City of Goshen Board of Public Works & Safety

Agenda for Claims Review & Approval Meeting

RE: Request for fence at 1111 South 12th Street, Goshen

RE: **1111 S. 12TH STREET – FENCE ENCROACHMENT REQUEST
(JN: STREETS)**

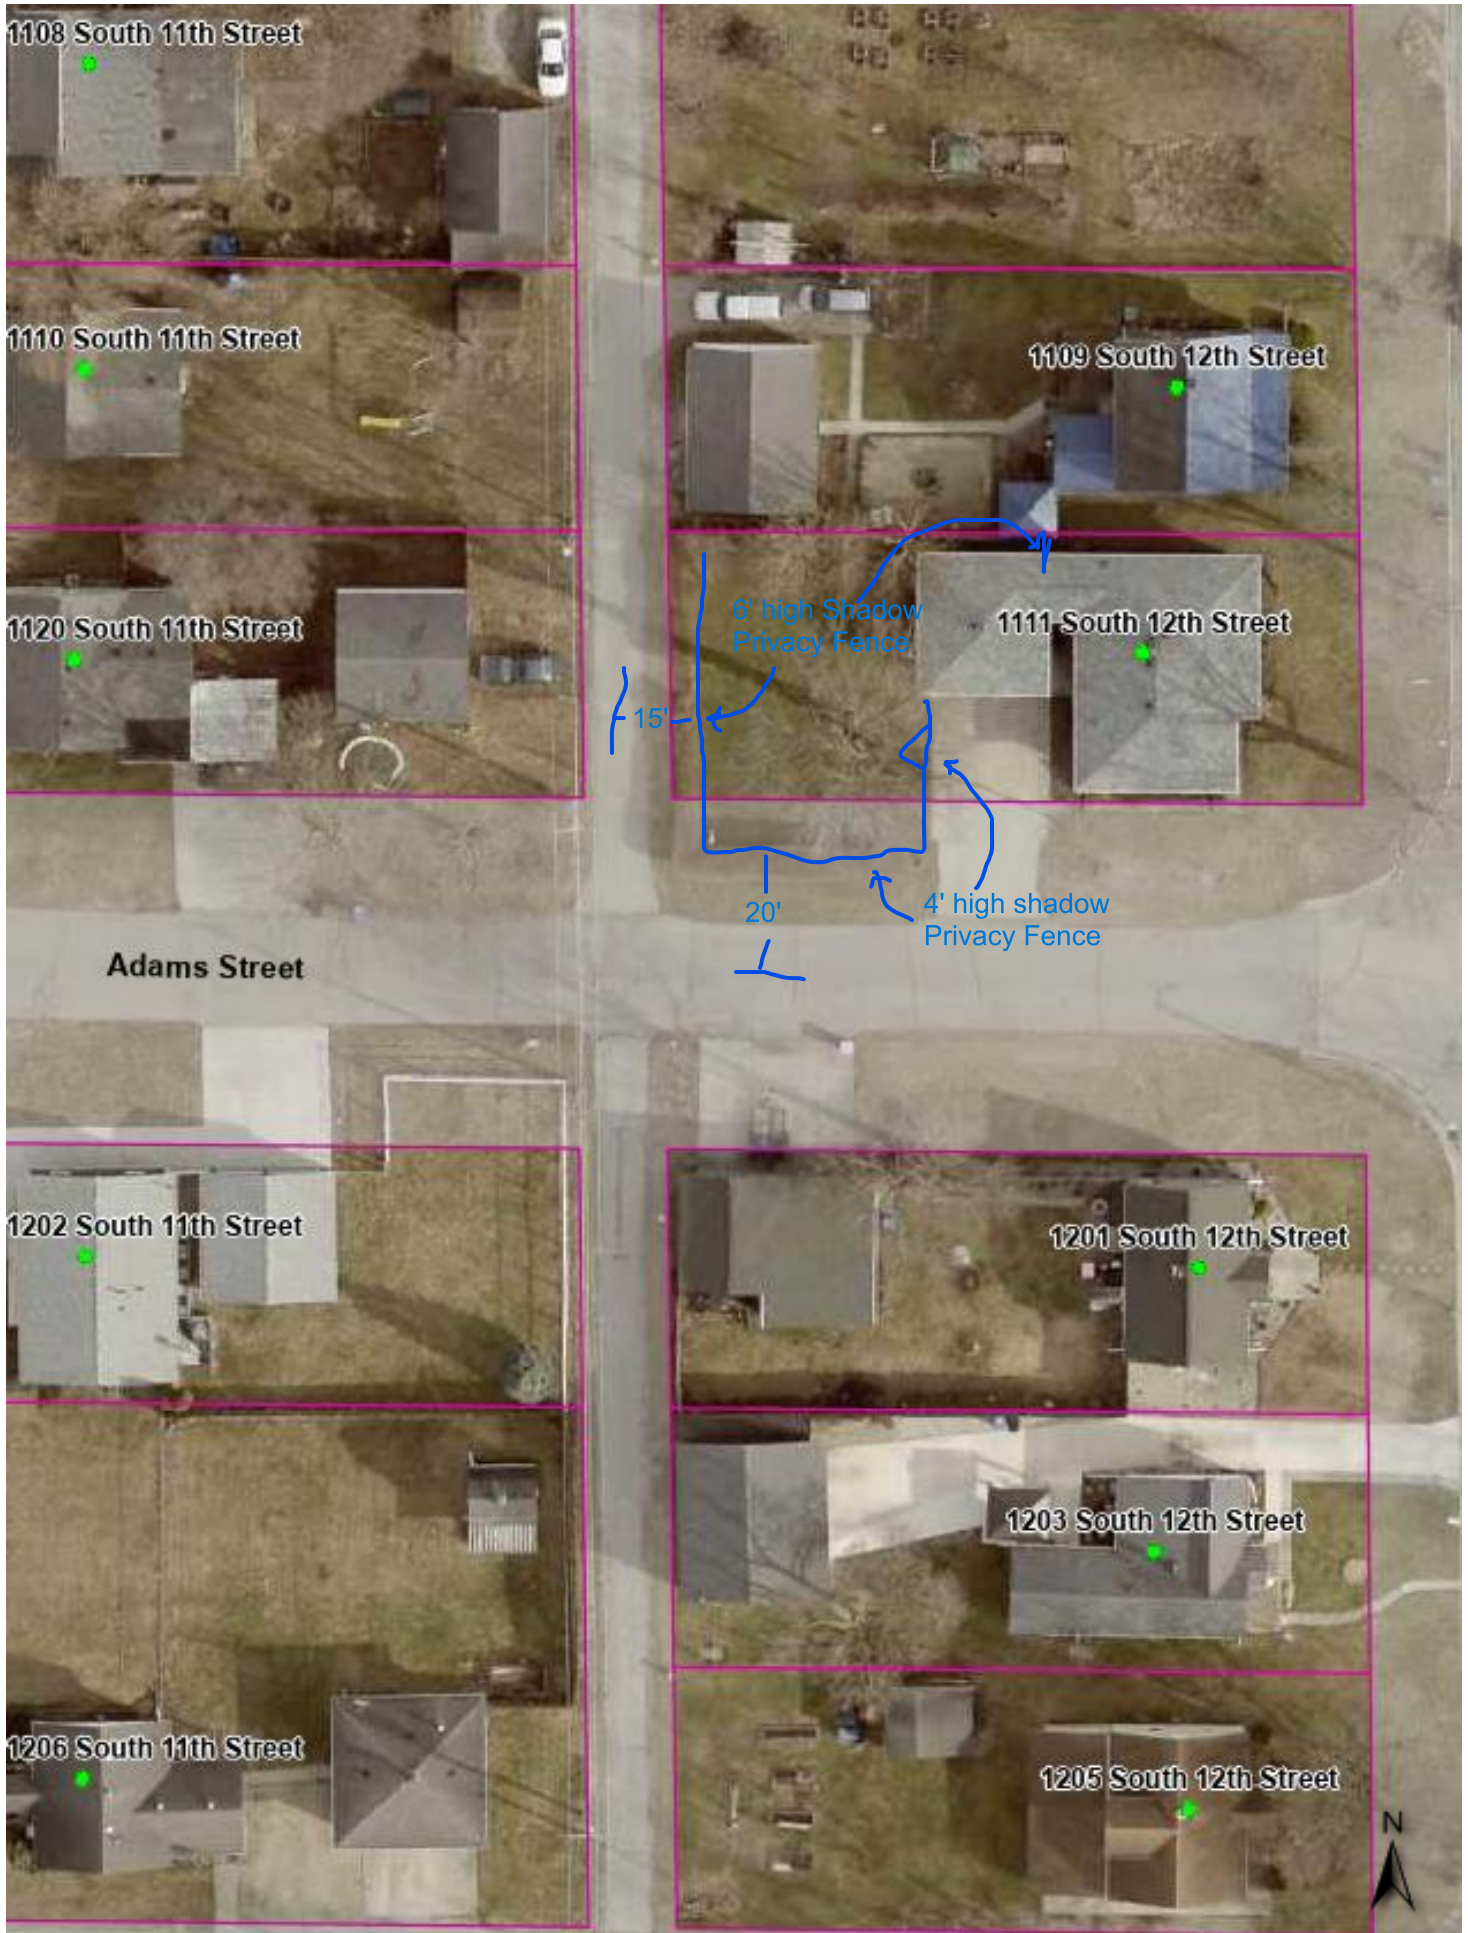
On the agenda for the June 11 Board of Works meeting is a request to place a fence within the right-of-way of Adams Street, which is associated with a residential corner lot at 1111 S. 12th Street. As proposed, the fence would be located 20' from the centerline of Adams Street.

Based on the City's records and a field locate on June 11, 2026, there is a public water main located on the northside of Adams Street, 10' from the centerline of the road which would be within 10' of the proposed fence where a minimum offset of 8' is required. The City does not have information on other private utilities that may be located within this right-of-way.

Goshen Engineering, serving as an agent of the Board of Works and Safety in the issuance of right-of-way permits, generally does not support private encroachments within the public right-of-way. With the existence of the water main within the treelawn, Goshen Engineering recommends the Board of Works and Safety deny the fence encroachment request.

Additionally, if the board were to entertain this request even with Goshen Engineering's recommendation, the item should be tabled until an 811 utility locate request is made to further confirm there are no additional buried utilities that would be impacted by the proposed encroachment.
